M5 Junction 10 Improvements Scheme

Applicants Response to Issue Specific Hearing 4 (ISH4) Action Points

Rule Number:	Rule 8 (k)
Planning Inspectorate Scheme Reference	TR010063
Application Document Reference	TR010063/APP/9.85
Author:	M5 Junction 10 Improvements Scheme Project Team

Version	Date	Status of Version
Rev 0	October 2024	Deadline 7

Internal Active Travel

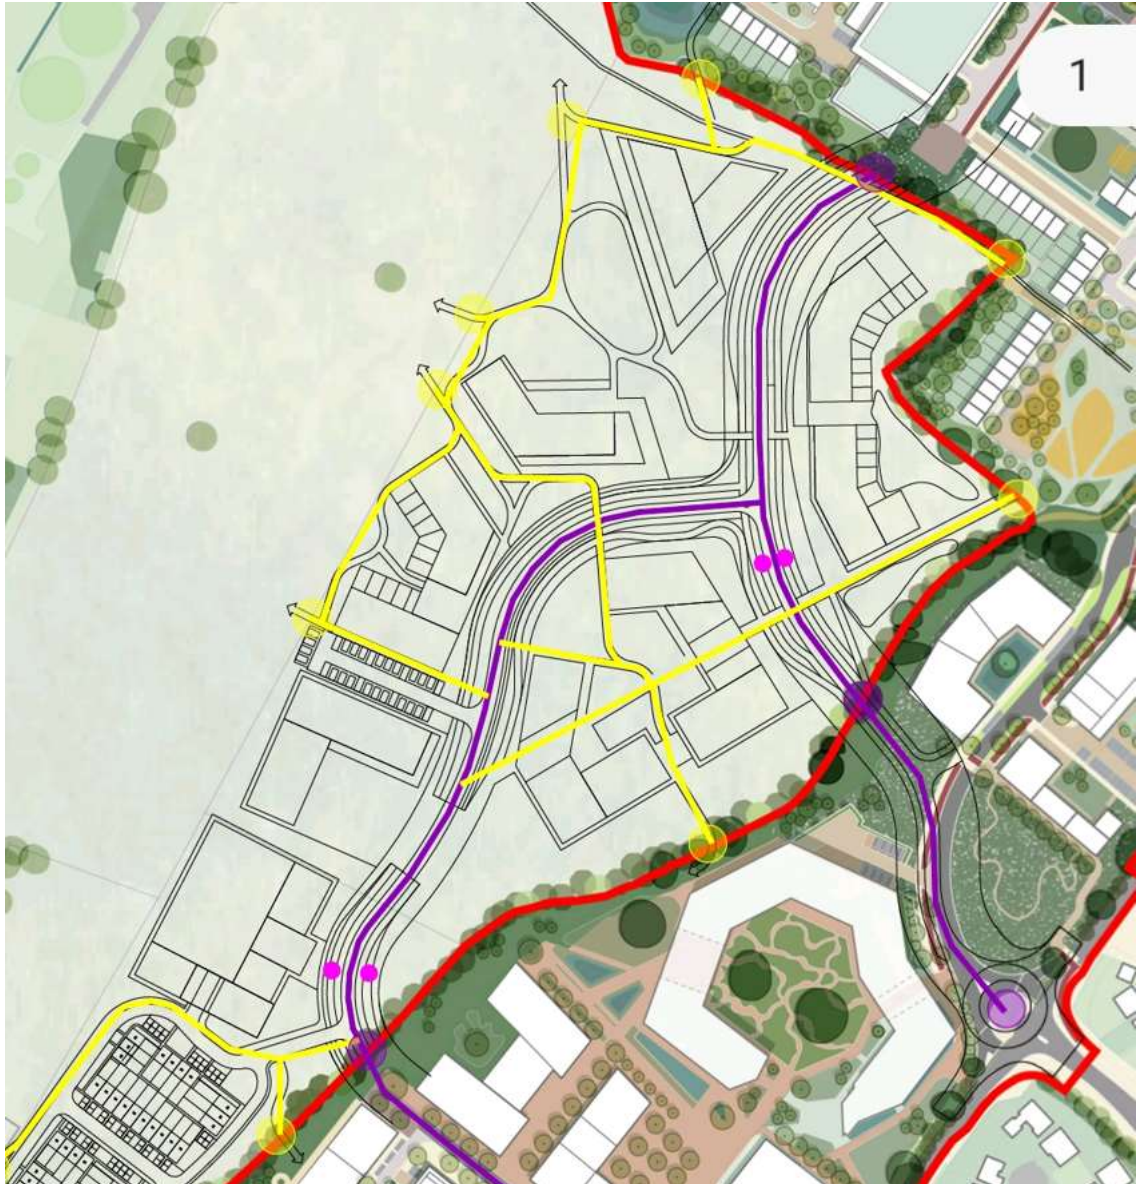
The Golden Valley Supplementary Planning Document (SPD) sets out that a key objective of the GV Development is to deliver an *“integrated and connected extension of West Cheltenham through the establishment of an open and permeable network of streets, a connected network of green off-road routes encouraging greater walking and cycling; the design and delivery of streets and junctions which prioritise the needs of people and sustainable modes”*.

The Transport Assessment (TA) indicates that *“Three all movement accesses are proposed along with ten active travel accesses. The proposed accesses have been designed to ensure a high level of permeability and accessibility for the site as well as providing options for different types of routes”*. The TA for this application has shown five active travel accesses between the application site and HBD site and goes on to say these are indicatively where they are shown on the HBD application. The extract from Figure 10 of the TA below shows a relatively high level of permeability, that at

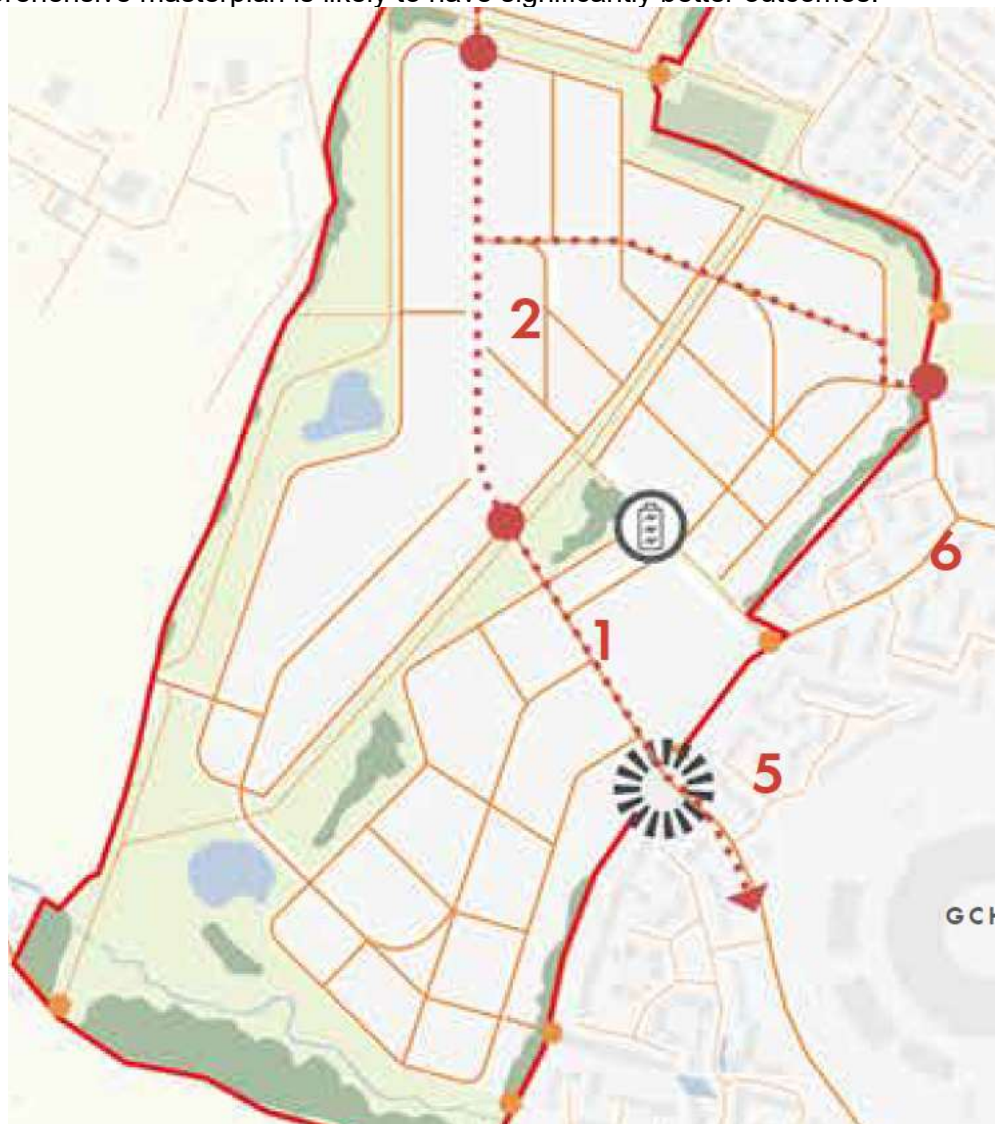
the needs of the whole Strategic Allocation. There does not appear to be any cooperation concerning the form of these linkages, their frontage treatment and their purpose for onward movement.

It is recommended that the JCS requirement for a comprehensive masterplan is followed. The SPD movement strategy was an illustrative framework and not a blueprint for development, however if the alternative road network that the HBD application proposes is consented, then that should be as part of comprehensive review of the linkages to this application site, so that still delivers the key objectives listed above. This would require cooperation on land boundaries. It should be noted that the SPD movements strategy illustrated a green corridor that does not respect land ownership boundaries as set out below. Adopting this approach through a comprehensive masterplan is likely to have significantly better outcomes.

This green corridor is broadly on the north/south alignment of the existing Springbank Way. This is partially replicated in the revised HBD revised masterplan. Although the SPD corridor not prescriptive, it is likely to have the best urban design outcome for the allocation as a whole. GCC are unable to recommend any meaningful planning conditions that help secure high-quality linkages without some form of joined-up plan.

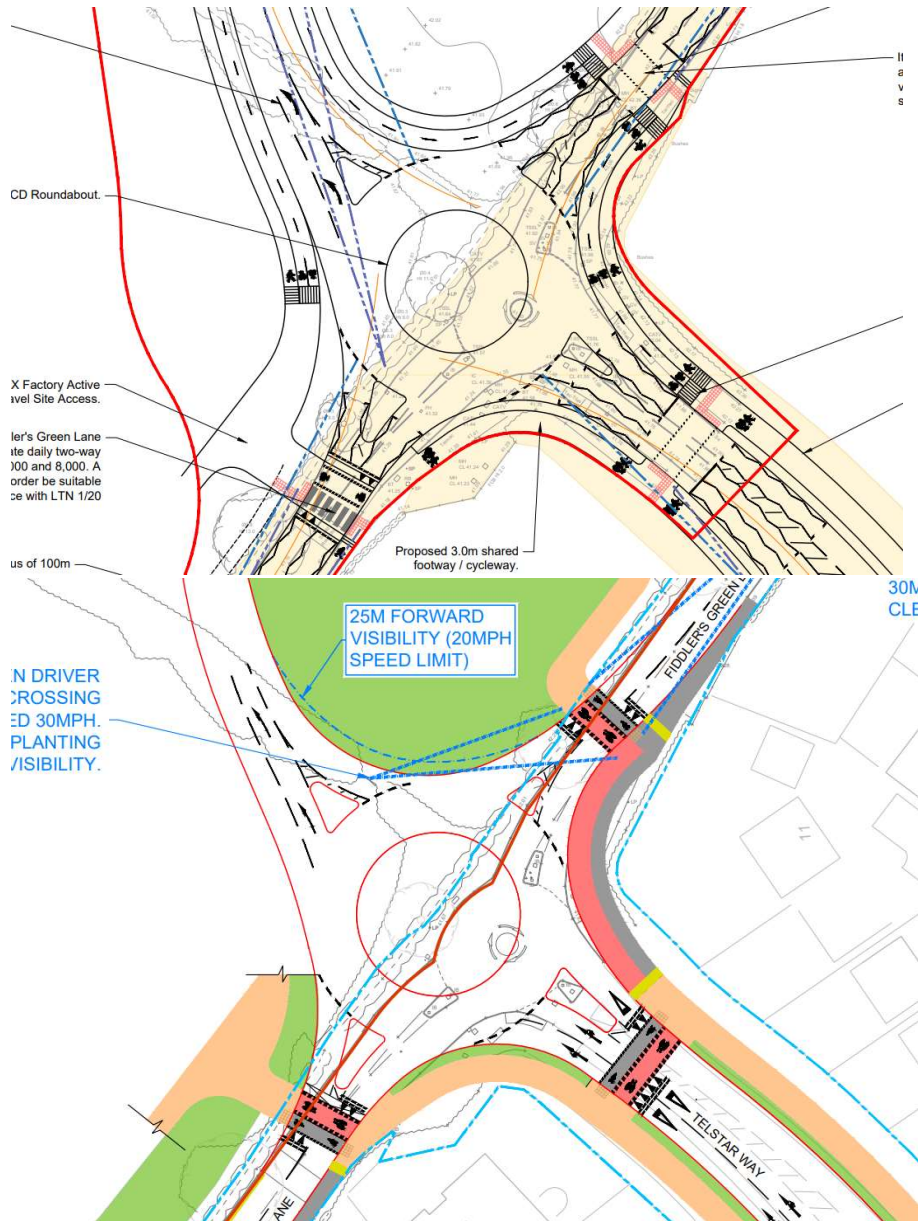
The above issue is not only present at the interface between the sites. At the site access the proposed Nema Option 2 roundabout which shows a 3m cycle track and 2m footway along their new access road to the proposed Telstar Way roundabout, with a potential onward link to the secondary access on Fiddlers Green Road. Whereas the HBD application shows no provision to walk or cycle alongside the site access road, (see image below), with their internal walking and cycling links being provided elsewhere.

Vehicle Access

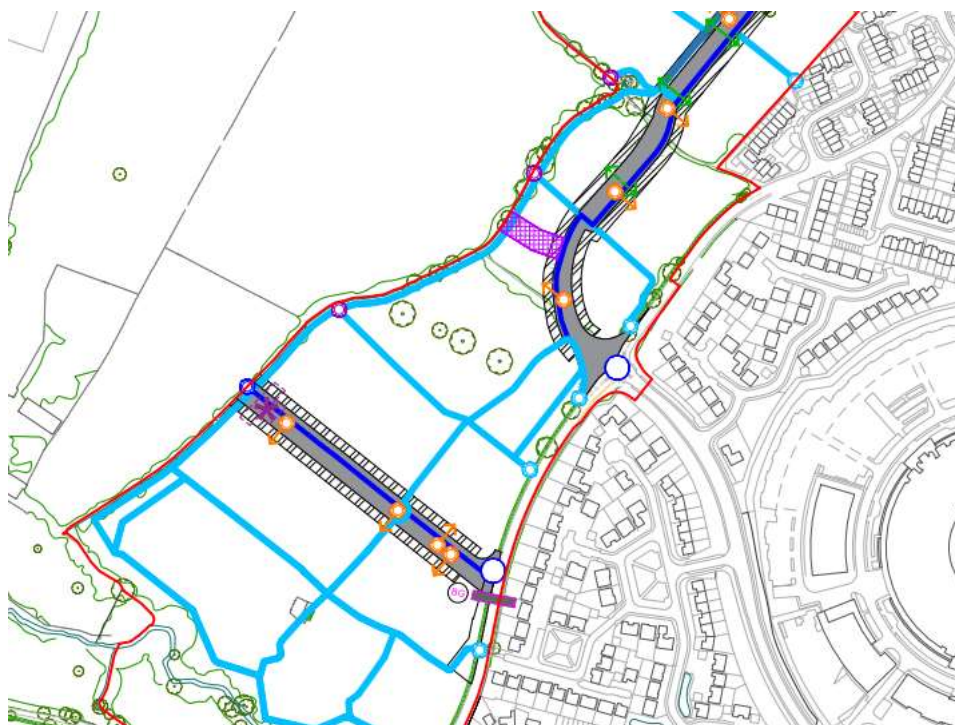
The TA outlines two Roundabout Options for the main site junction with Telstar Way. A 50m diameter roundabout based on a higher level of potential combined development traffic and a smaller 36m diameter roundabout which assumes a lower level of traffic and the successful implementation of a Transport Strategy. The HBD application proposes a 36m diameter roundabout; currently the County Council are awaiting more information from HBD concerning their Framework Travel Plan and how their measures will achieve the anticipated lower level of traffic. The County Council consider that the smaller 36m diameter roundabout may be able to cope with the levels of traffic arising from the proposed vision for the sites, provided of course there are adequate measures to incentivise alternative means of travel and discourage car use. The same Travel Plan work needs to be undertaken for this application, establishing a

clear link between the proposed sustainable transport intervention and the resulting anticipated change in travel behaviour. Therefore the County Council are currently unable to support either Option 1 or 2 until such time as the Travel Plan measures are finalised.

The proposed southern vehicle access onto Fiddlers Green Lane matches the alignment shown in HBD's proposal. Depending on the results of the Travel Plan discussions, it may be necessary to change the priority of traffic at the Fiddlers Green junction and the location of the bus gate, to distribute some of the site traffic to Arle Court roundabout rather than funnelling it all via Telstar Way.

The proposed southern vehicle access to Fiddlers Green significantly differs from the HBD proposals in terms of road width, footway, cycleway and verge provision, which appear completely different. This needs to be addressed through a comprehensive masterplan.

The proposed central vehicle access that links to the Testar Way roundabout does not appear to be compatible with the HBD layout. The adjacent HBD site has made a revised submission that includes a parameters plan for movement which does show a link to this application site as indicated below in purple. This is broadly in the correct location, however it still needs to resolve whether the active travel corridor will follow the road or be elsewhere as suggested by the light blue links below. This needs to be resolved through a comprehensive masterplan.

The proposed northern access to the HBD site significantly differs from the HBD proposals in terms of road width, footway, cycleway and verge provision, which are completely different. Indeed, the HBD indicative arrangement only shows a very minor access road in this location which is unlikely to be compatible with buses. This needs to be resolved through a comprehensive masterplan.
